# SFQ Cassette Modification

Panduit Small Form factor QuickNet (SFQ) Cassettes have been modified to achieve uniformity across Panduit's cassette lines and to fully comply with the wiring sequences dictated in standards TIA-568-C.0 and TIA-598-C. Although cassettes are not identified or defined in the TIA-568-C.0 cabling standard, Panduit has decided to pursue this change to meet the special circumstances and needs of our customers. This wiring change ensures that Panduit Cassettes are fully interoperable with all products that fully comply with the Method A polarity guidelines.

**Figure 1. TIA-598-C standard for MPO Key Up to LC Key Down Breakout Cable Assembly**

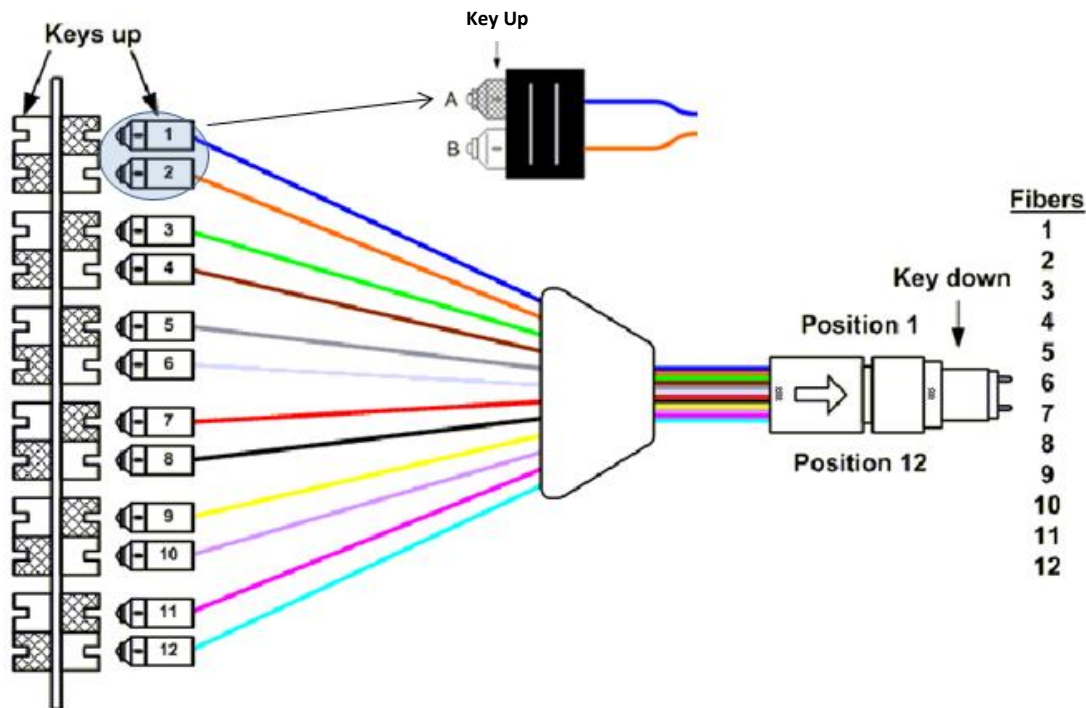
As seen in Figure 1 below, the TIA-598-C color standard for a breakout cable that is MPO key down and LC key up dictates that Fiber 1 is blue, Fiber 2 is orange, etc. All odd fiber numbers are positioned in the A-side of the duplexing clip and all the even fiber numbers are positioned in the B-side of the duplexing clip.

Figure 2. Alternative wiring for TIA-598-C Breakout Cable Assembly

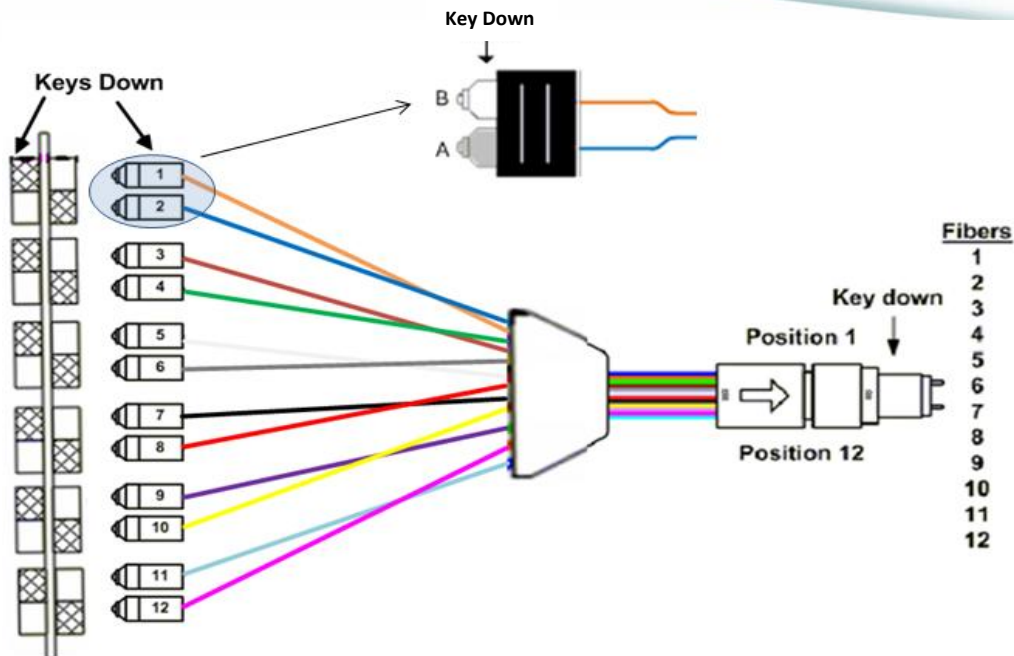
If the LC portion of this assembly was to be designed key down, fibers one and two would just switch positions so Fiber 1 is now orange, Fiber 2 is now blue, etc...Even with this key rotation, the assembly layout still dictates that the odd fiber numbers are positioned in the A-side of the duplexing clip and all the even fiber numbers are positioned in the B-Side of the duplexing clip as shown in Figure 2. The result of this alternative scheme shown in Figure 2 is a flip in the A-B duplexing.

To meet the ever increasing requirement of product interoperability, Panduit has modified the SFQ cassettes to reflect the wiring in Figure 2 so that the first channel, Fiber 1 (blue) starts on the A side of the duplex adapter, which in turn follows TIA-568-C.0 standard and is now compatible with all fully compliant Method A products on the market.

Figure 3. MPO Key Down to LC Key Down Wiring in Legacy SFQ Cassette Assembly

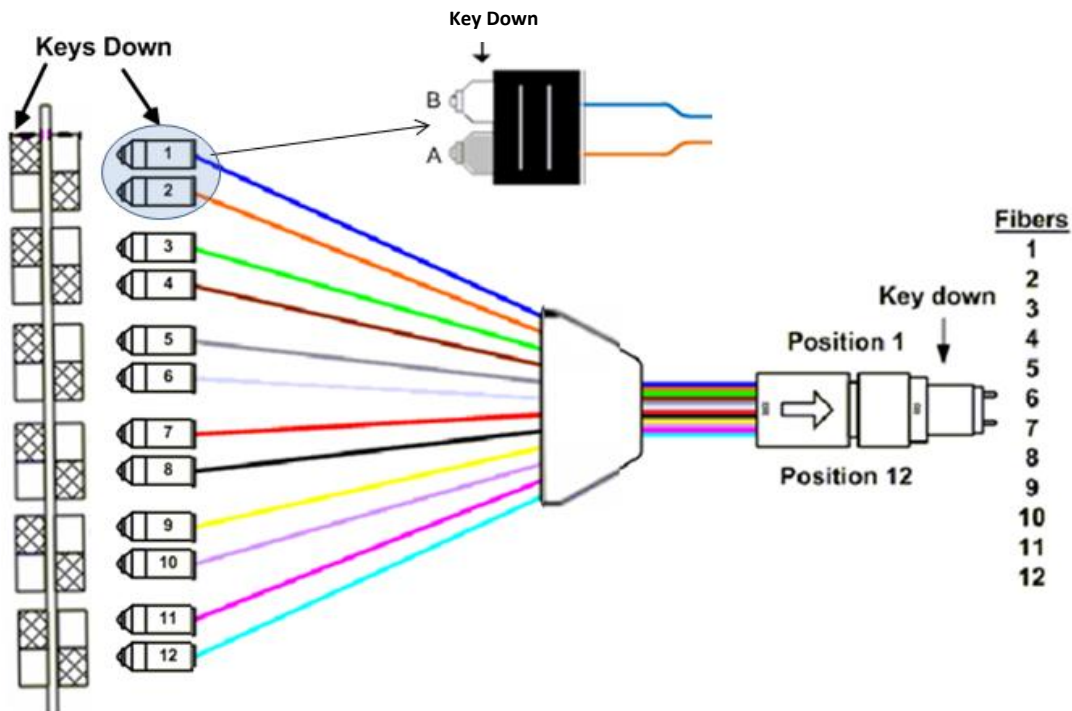
Legacy Panduit SFQ cassettes had a fiber layout with LC key down as shown in Figure 2 but with the wiring of Figure 1. The wiring in the legacy SFQ cassettes is shown below in Figure 3 and has the odd fibers positioned in the B-side of the duplexing clip and the even fiber numbers positioned in the A-side of the duplexing clip.

In most cases this causes no issues to an installation. However, for those instances where the legacy Panduit SFQ cassette connects to a fully compliant Method A product, a simple solution is to use a patch cord where the LC connectors are switched in the duplex clip.
